NEWMAR CORPORATION WARRANTY DEPARTMENT

TECHNICAL SERVICE BULLETIN

DATE ISSUED	MODEL YEAR(S) AFFECTED	TSB #
3/24/2016	2016	449 rev. A

NHTSA# 16V 041, TC # 2016-034

Original Incorrect Label

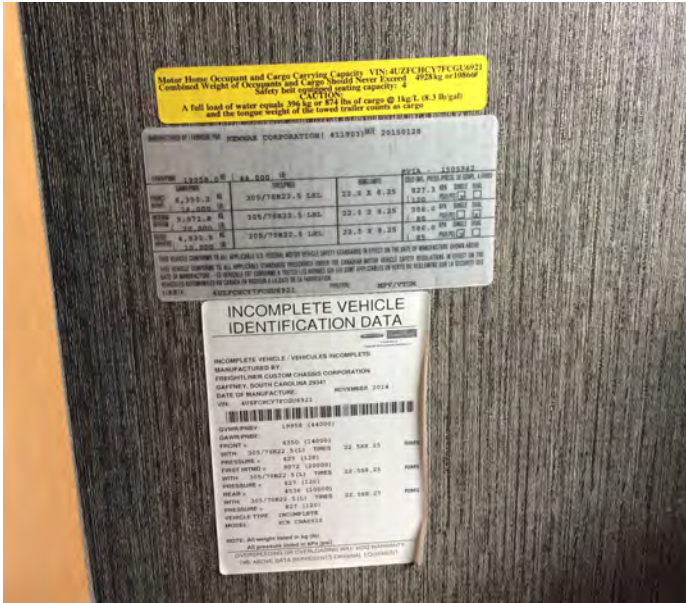
Newmar Corporation has decided a defect relating to motor vehicle safety exists in specific motor homes. In response to notification from Freightliner Custom Chassis Corporation, an incorrect front tire inflation level is shown on their provided 'Incomplete Vehicle Label.'

Issue: Inflation of the tire beyond the manufacturer's maximum pressure rating may increase the risk of a crash, resulting in injury and/or damage to property.

Correction: Freightliner will send Newmar a new label with the correct 120 PSI rating for the tires. Newmar will mail the correct label to the customer. Check the tire pressure to verify that the pressure does not exceed the maximum pressure rating as printed on the new label.

Method #1: Removing the Original Label

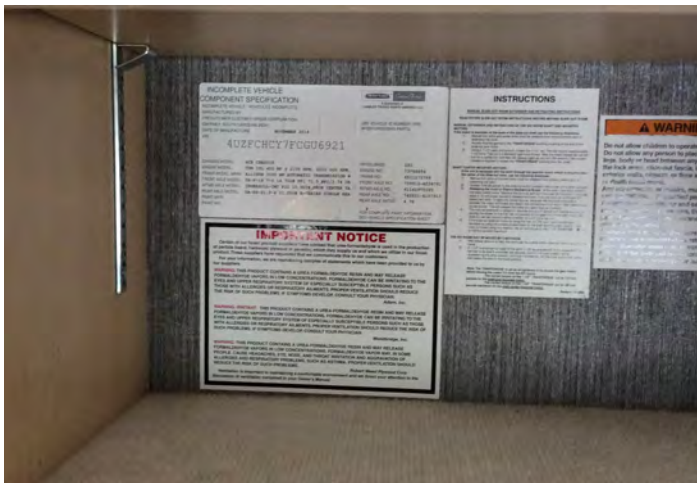
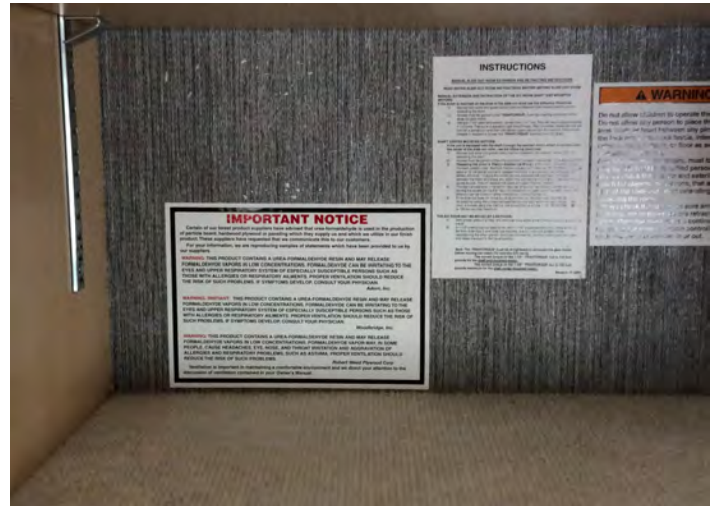
2. Clean the existing label with rubbing alcohol. If the edges are peeling, it may be easier to remove the label. If you are installing a new label over the top of the existing label, take care to align the new label directly over the old label so that it is covered completely.

3. Install a clear protective film over the new label.
4. Repeat the process for the label in the kitchen cabinet.

Old Label Removed

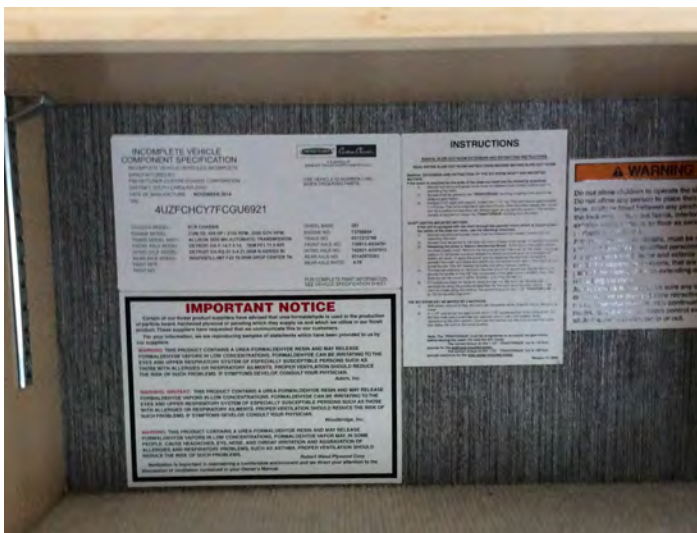
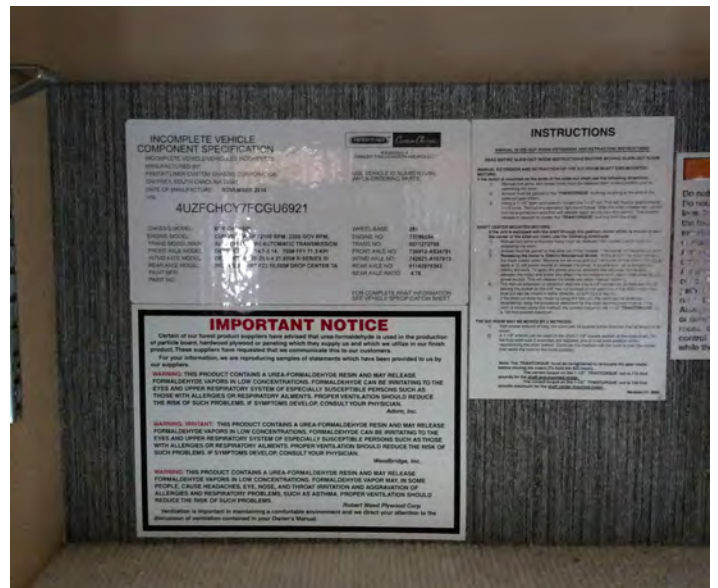
5. Locate the label in the kitchen cabinet. To install the new label, clean the existing label with rubbing alcohol. If the edges are peeling, it may be easier to carefully remove label. If you are installing a new label over the top of the existing label, take care to align the new label directly over the old label so that it is covered completely.

6. Install clear protective film over the new label.
